After reviewing the response to RAI 208-8245, Question 03.08.03-1, the staff have identified a need to review the below. We have some preliminary info we would like to see. Please see if you can put the below 2 items in the ERR:

KHNP INPUT

Figure 1. The Scaling Factor with Different Initial Pool Temperature

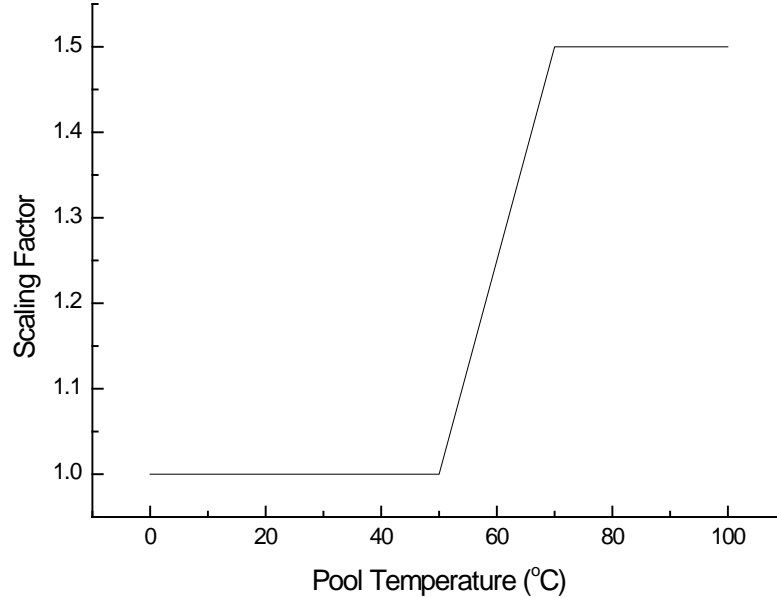
- 1) background for the scaling factors for part (a) (see below), specifically, n-sub-g, n-sub-z, and n-sub-v.
- 2) We also need to confirm that the equation on page 5/9 refers to $r > 2r_0$ rather than just "0" (We have the background info that corroborates this, so this should just be a simple confirmation of a typo).

The Studsvik tests have indicated that the maximum pressure amplitudes are increasing noticeably with increasing pool water temperature above a level of about 50-60 °C. The scaling factor to account for differences in initial pool water temperatures is shown in the Figure 1. The maximum initial IRWST temperature is 120 °F (48.9 °C). Therefore, the scaling factor to account for differences in the pool water temperature, η_T is 1.0.
